UNITED STATES DEPARTMENT OF COMMERCE
Patent and Trademark Office

09/893,669 06/29/01 JANG

Office Action Summary

DETAILED ACTION

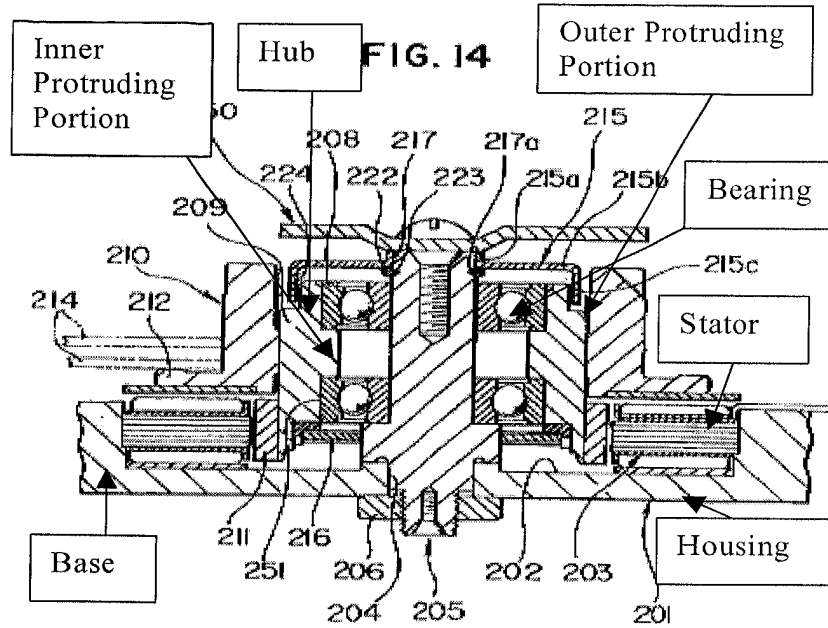
1. Figure 1 should be designated by a legend such as --Prior Art-- because only that which is old is illustrated. See MPEP § 608.02(g).
2. The drawings are objected to because Fig 2a and 2b are missing a reference line for the permanent magnet which is to number as 260. Correction is required.
3. The drawings are objected to as failing to comply with 37 CFR 1.84(p)(4) because reference characters "251" and "252" have both been used to designate the inner protruding portion of the hub, claim 1 lines 15 and 19. Correction is required. For the purpose of advancing prosecution on the merits the examiner will assume that the disk of claim 1 is mounted on the upper face of the outer protruding portion.

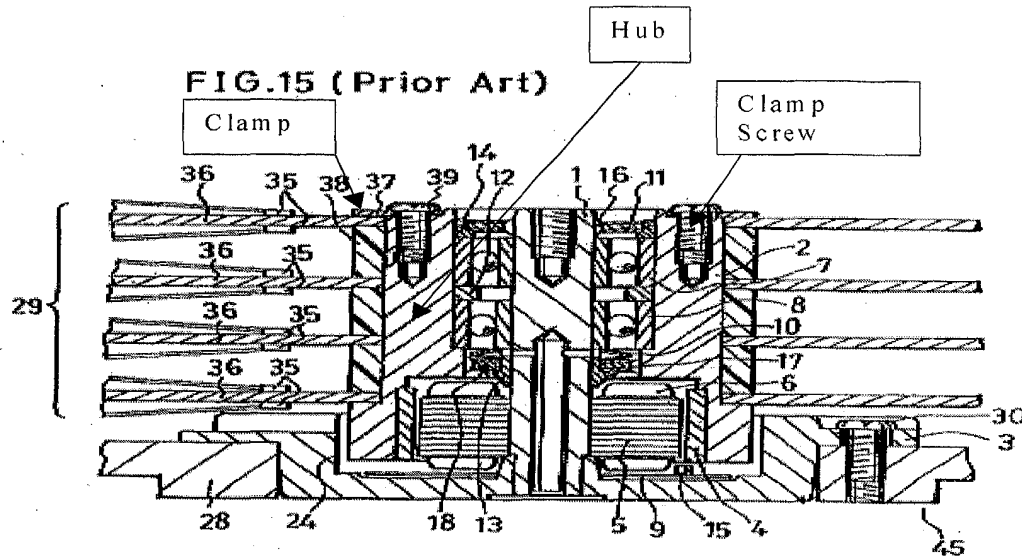
Takemura et al. illustrates a spindle motor in Figure14, which consists of a fixed shaft 205 mounted in a circular hole within the central portion of the base 201, a cylindrical hub with an outer protruding portion at the upper inner face of the hub and an inner protruding portion of the hub between the upper and lower ball bearings 208 and 251, a permanent magnet 211 which is attached to the lower outer face of the outer protruding portion of the hub, a stator 203 that is attached to the upper end portion of the inner circumferential face of the base, and a disk 214 which is mounted to the outer protruding portion of the hub. However, Takemura et al. does not teach the use of a spindle motor in which a clamp is attached to the hub with bolts that mount a disk and does not demonstrate that the permanent magnet is attached to the lower outer protruding portion of the hub.

Sakuragi et al. shows in Figure 15 a permanent magnet that is attached to the hub by the lower inner protruding portion of the hub. Sakuragi et al. illustrates in Figure 15, a spindle motor with a clamp 37 attached to the hub 2 with bolts 39 to mount a disk 36.

It would have been obvious to one ordinary skill in the art at the time the invention was made to modify the device in Takemura et al. to have a clamp attached to the hub by a bolt in which a disk is mounted to for the purpose of securing the disk to the rotor as disclosed in Sakuragi et al.

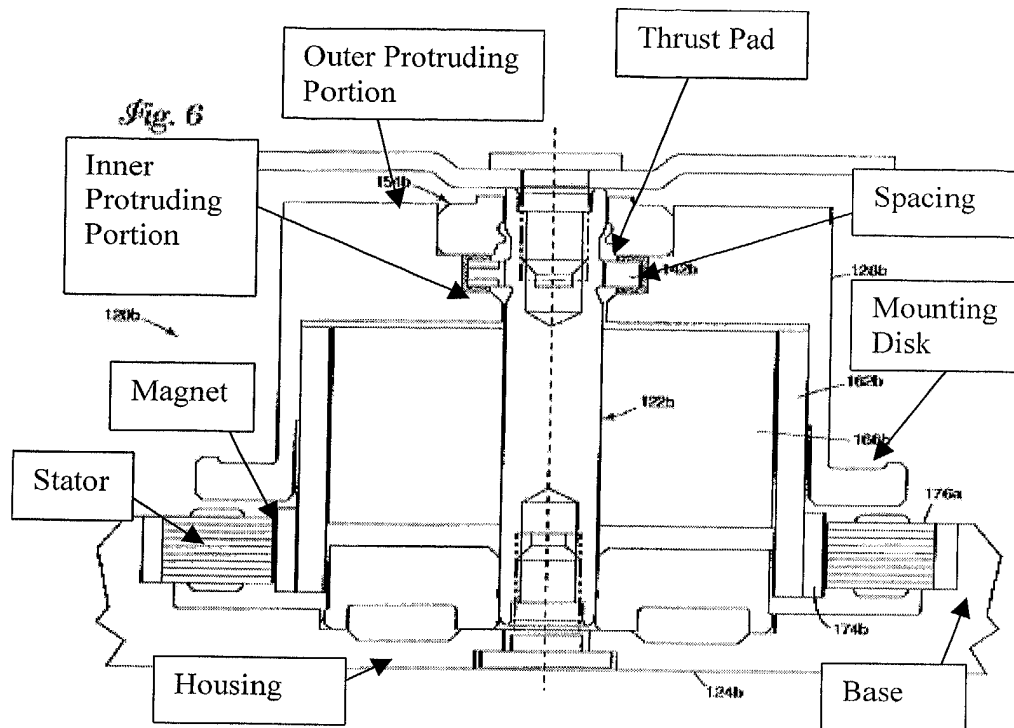
Lee discloses in Figure 6 a spindle motor 120b with a fixed shaft 122b that includes a inserted thrust pad spaced from a hub 128b, an outer protruding portion of the hub, an inner protruding portion of the hub, a permanent magnet 174b that is bonded to a lower side of the outer circumferential face, a stator 176b bonded to an upper portion of the housing, a base plate 124c with a circular hole into which the housing is attached. It would have been obvious to one ordinary skill in the art at the time the invention was made to have combined the spindle motor design of Takemura and the thrust pad of Lee with the attachment of the clamp and bolts to the hub of Sakuragi to secure a disk to the rotor and to attach a permanent magnet to the lower outer protruding portion of the hub.
